Subject: Crystal Geyser Final Environmental Impact Report (FEIR) – Comments on Noise Issues

Regarding CEQA Consultant's Responses to DEIR Comment Letter P77 (GEOFFREY HORNEK)

Regarding the *Updated Environmental Noise & Vibration Assessment Crystal Geyser Bottling Plant EIR* (BAC August 7, 2017) (Appendix T) - Beginning on Page 35 of the BAC report

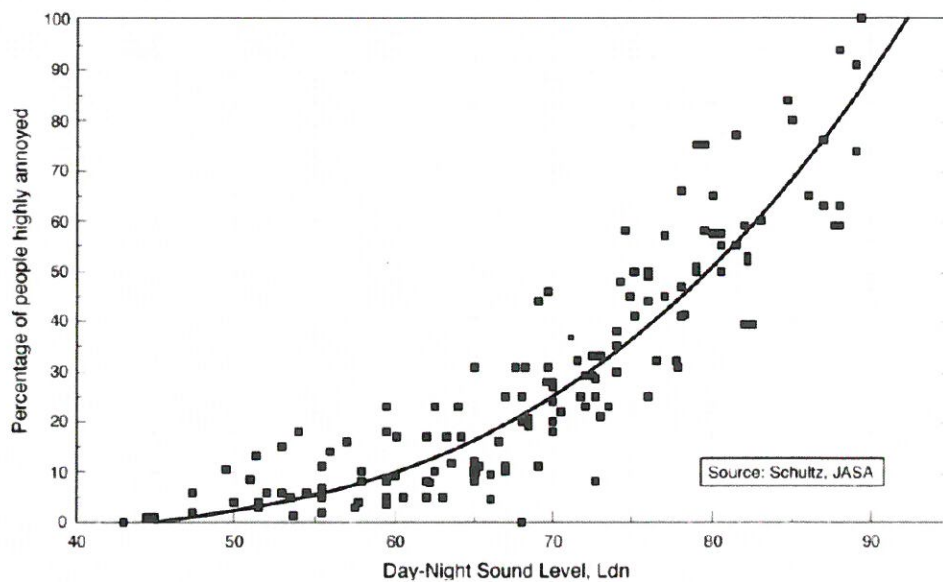
Personal perceptivity and sensitivity to noise and resulting personal annoyance from noise are not relevant to CEQA significance criteria, but community perceptivity and sensitivity to noise and resulting community annoyance from noise most certainly are. In fact, data from surveys of annoyance levels in different communities exposed to varying 24-hour average levels of ambient noise (see figure below) are the basis of FTA's incremental noise impact criteria are commonly used in CEQA analysis.

FTA criteria should be universally used for transportation noise sources since the basis for their development is compelling. In contrast, other incremental criteria are unsupported by scientific evidence, particularly the criteria below recommended by Caltrans and cited by BAC on page 3 of the project noise technical report.

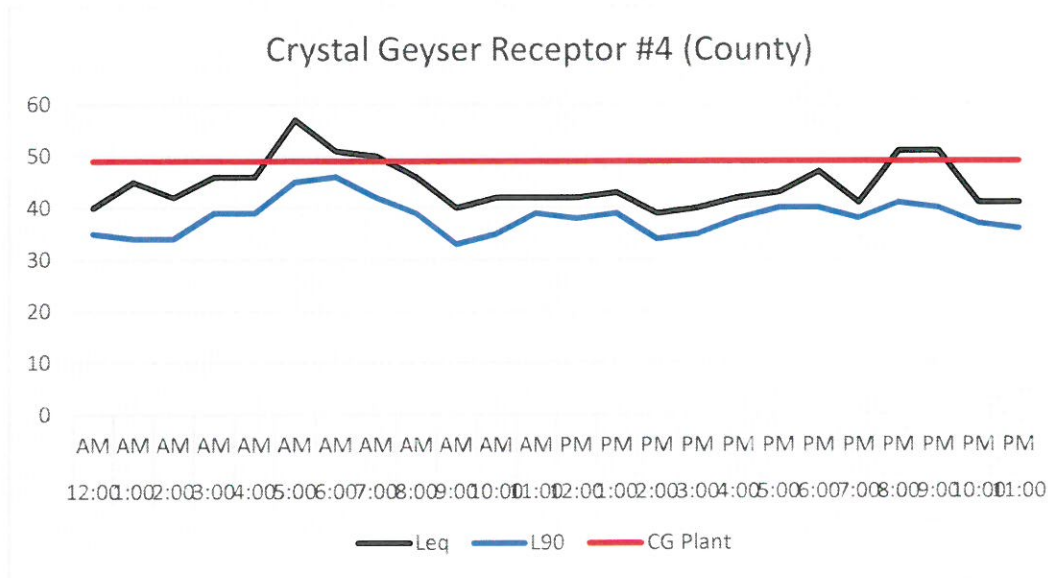
It is the City's policy to increase its noise exposure standard by 5 dB if existing noise levels at a receptor already exceed that threshold by a lesser amount. But it makes no sense to use this policy in CEQA analysis. The purpose of CEQA is to inform the public and protect it from adverse environmental impacts whenever possible. If the existing noise levels at a particular receptor near the GC plant exceeds the City standard by 1 dB, how can it be justifiable to say that a project noise source can increase the noise level by another 4 dB before it can be called significant in the CEQA analysis?

There is an overarching CEQA mandate to inform and protect the public from adverse environmental impacts from new development. The FTA standards have by far the stronger scientific basis and greater support among regulatory agencies. They are more restrictive than the FICON standards and, therefore, are more protective from incremental noise from transportation sources.
